REGIONAL REVIEW NOTIFICATION

ARC REVIEW CODE: R809301

Name of Proposal: 777 Memorial Drive
Review Type: Development of Regional Impact

Preliminary Report:	September 30, 2008	DEVELOPMENT OF REGIONAL IMPACT REVIEW REPORT	Project:	777 Memorial #1909
Final Report Due:	October 30, 2008		Comments Due By:	October 14, 2008

A1.0

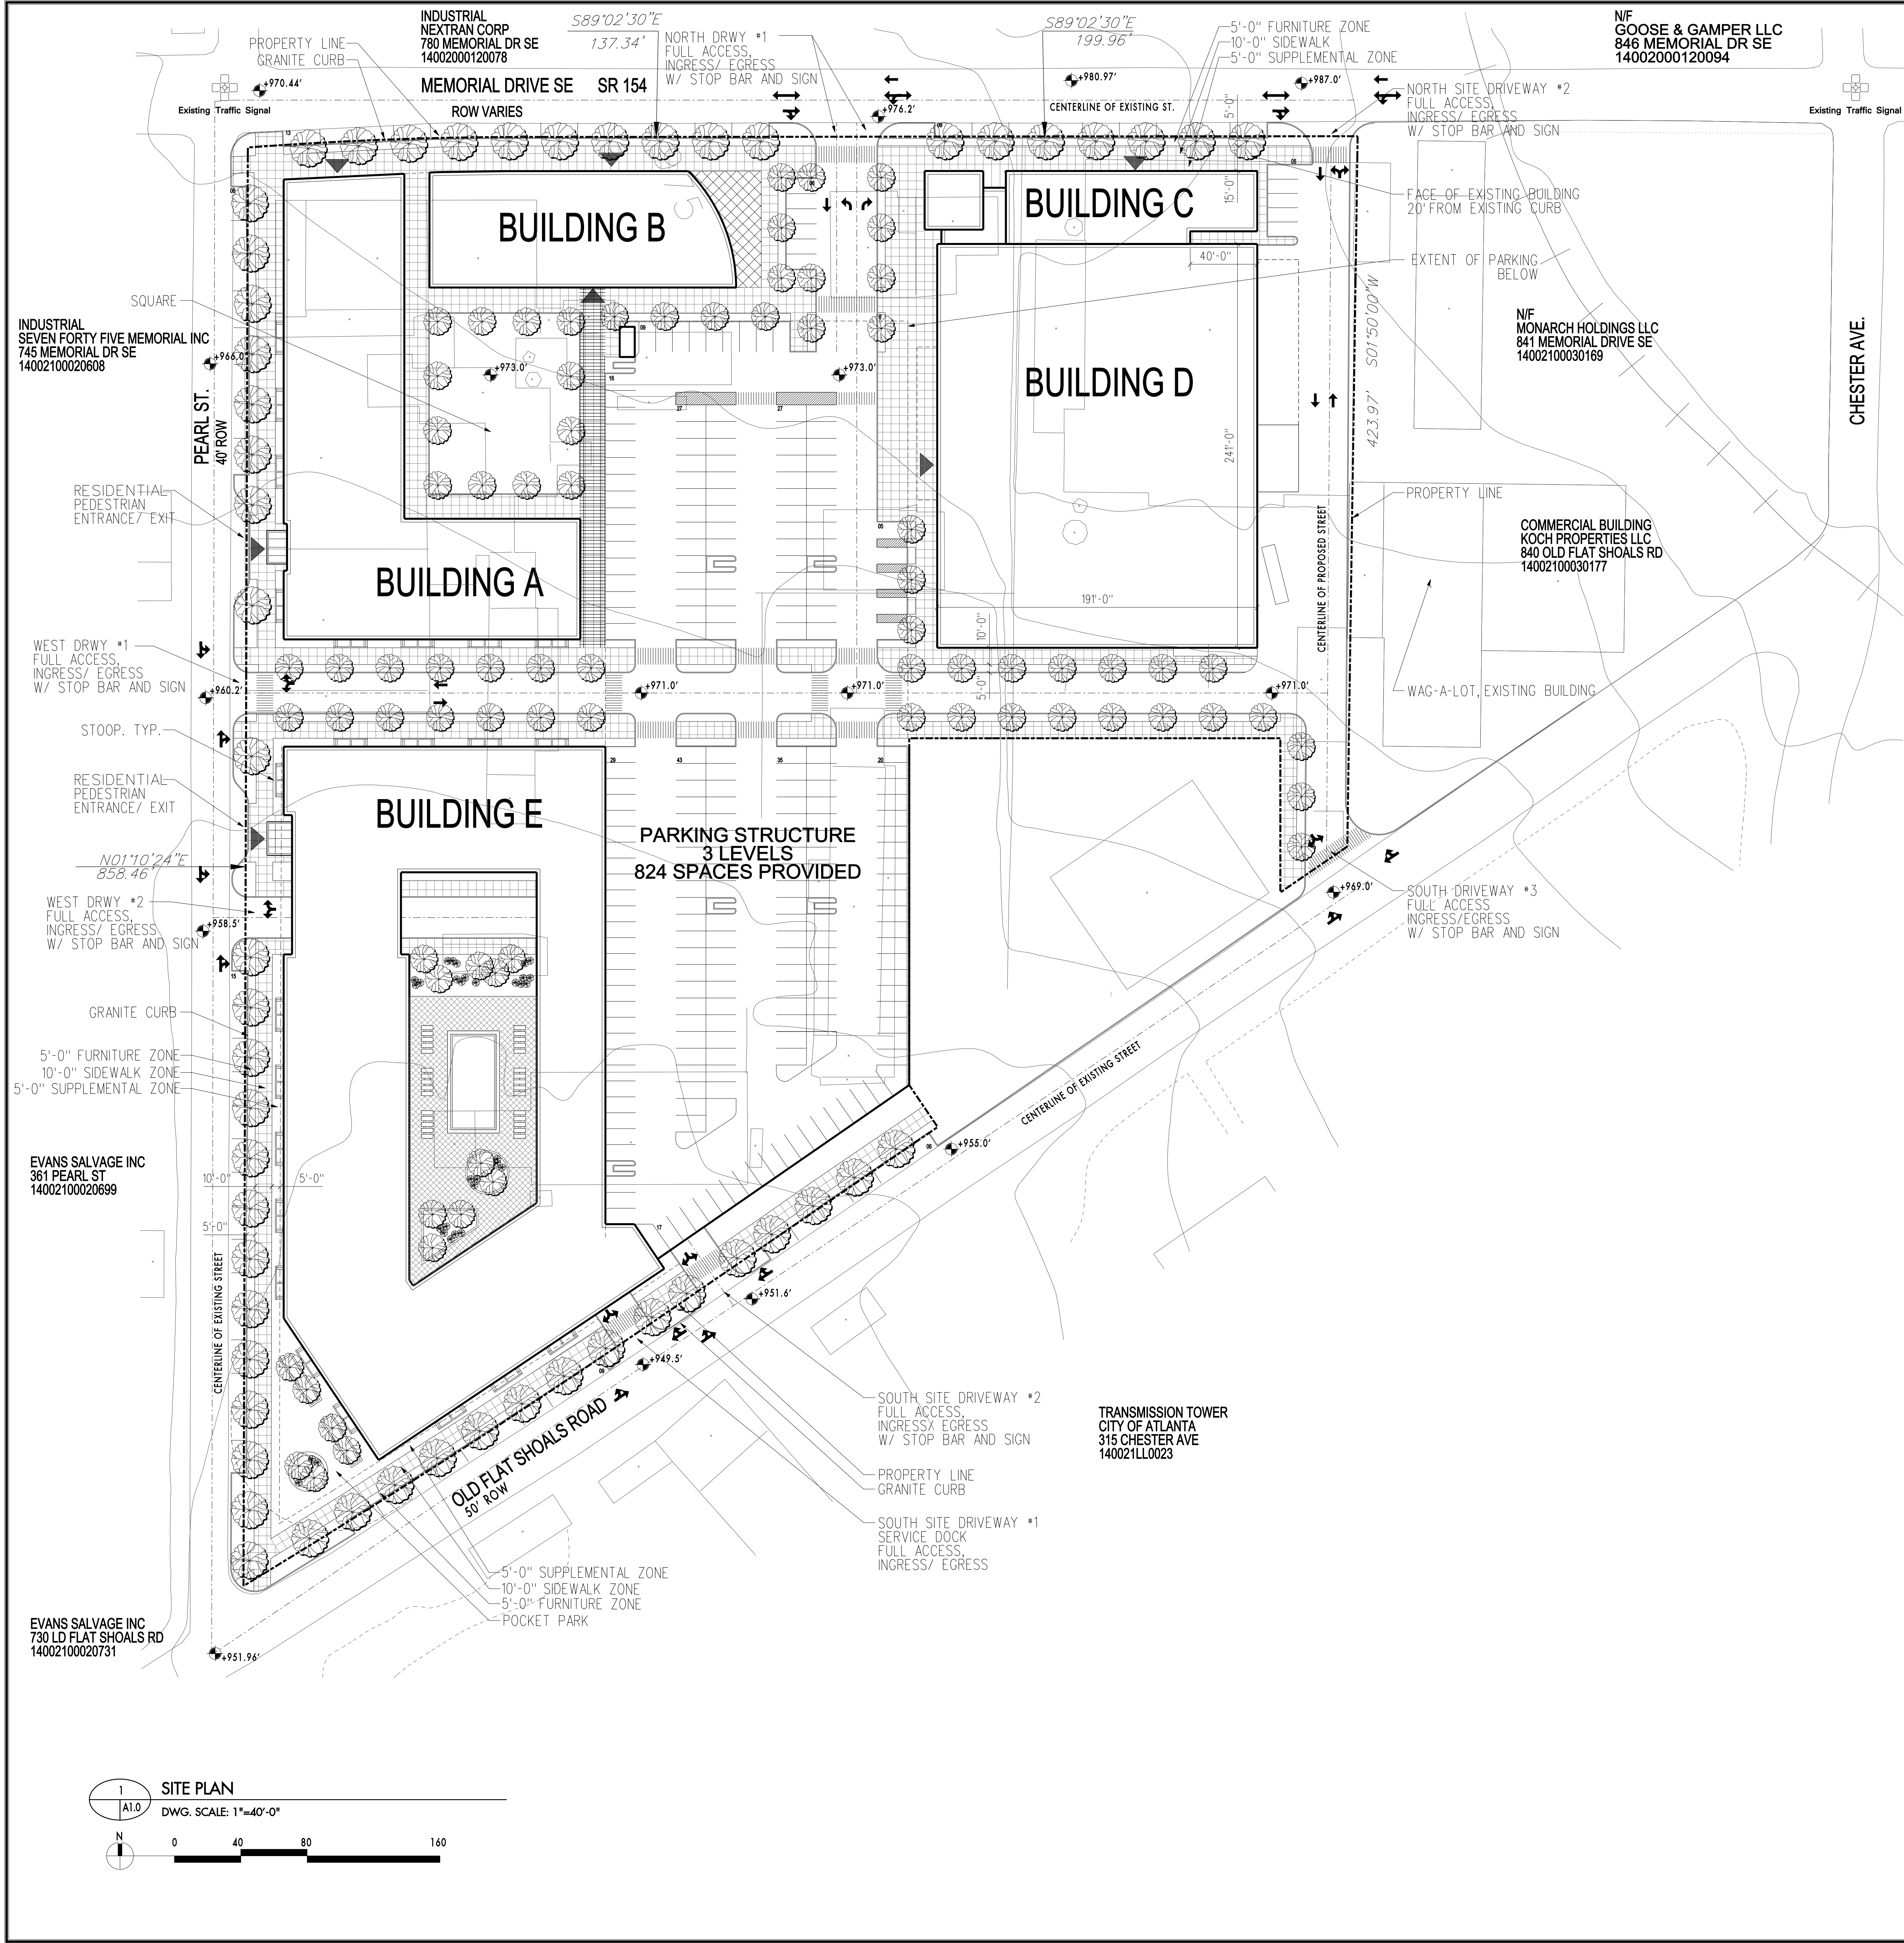
- The two full-access driveways proposed on Memorial Drive are in close proximity to each other, and the nearest public roadways (Pearl Street and Chester Avenue). ARC is concerned with the proximity and will examine the issue in closer detail during the remainder of the review period.
